2501 Richmond

COMMUNITY QUESTIONS & RESPONSES

December 2024

minto
Communities

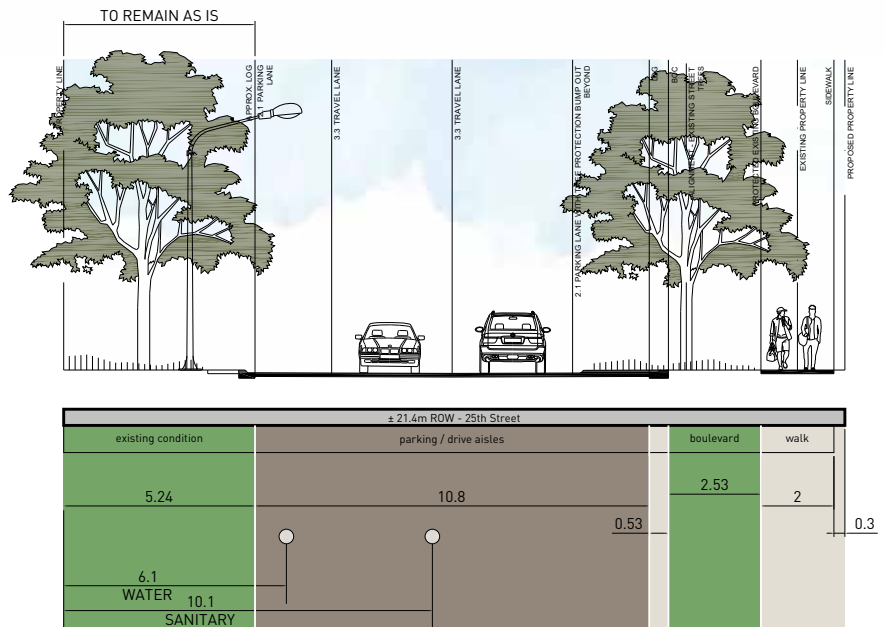
<p>What is the plan for the 29 Street and Richmond Road SW intersection? Turning off Richmond Road onto 29 Street is challenging.</p>	<p>The analysis concluded that with 1,250 new units at this site, an additional signal at 29 Street and Richmond Road SW would be beneficial but not required.</p>

C: 25 Street S. W.
 Modified Collector - (10.8m / 21.4m)
 2.0m Sidewalk on one side Scale: 1:200

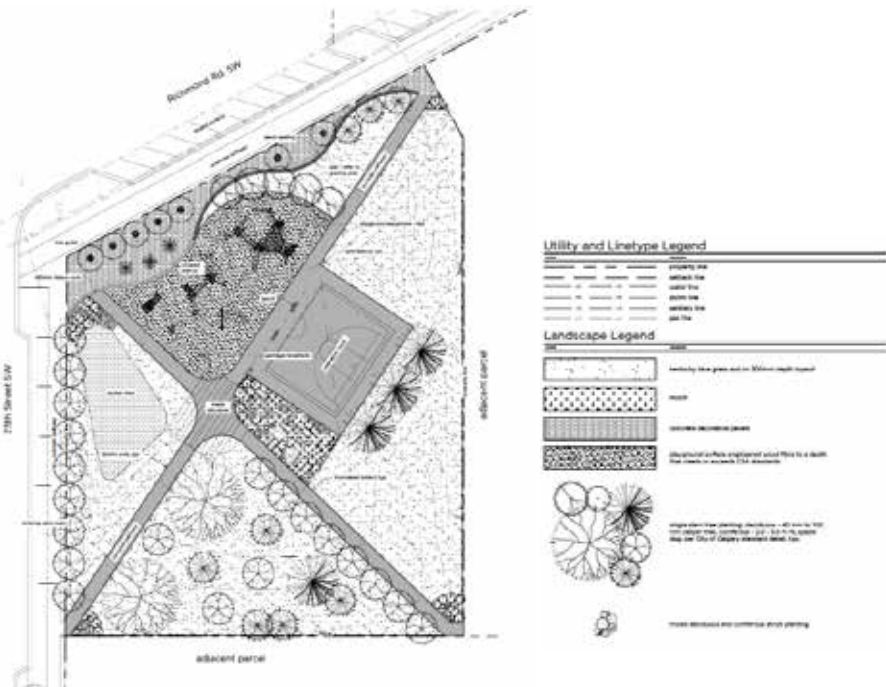
What road upgrades will be made to 25 Street SW along the site boundary, and will you require land from existing homes to accommodate these changes?

Upgrades to 25 Street SW will not impact existing homes long the west side of the road. Our site and the east side of 25 Street SW will accommodate all proposed changes.

We are pleased to share the cross section for 25 Street SW again. The cross-section shows the west side remaining as is. The east side will be updated to include a 2.53m boulevard with 2m sidewalk. At bump-outs this will widen to a 4.63m boulevard and a 2m sidewalk. This, along with other street details, can be found on the October 2024 outline plan shared on our website.
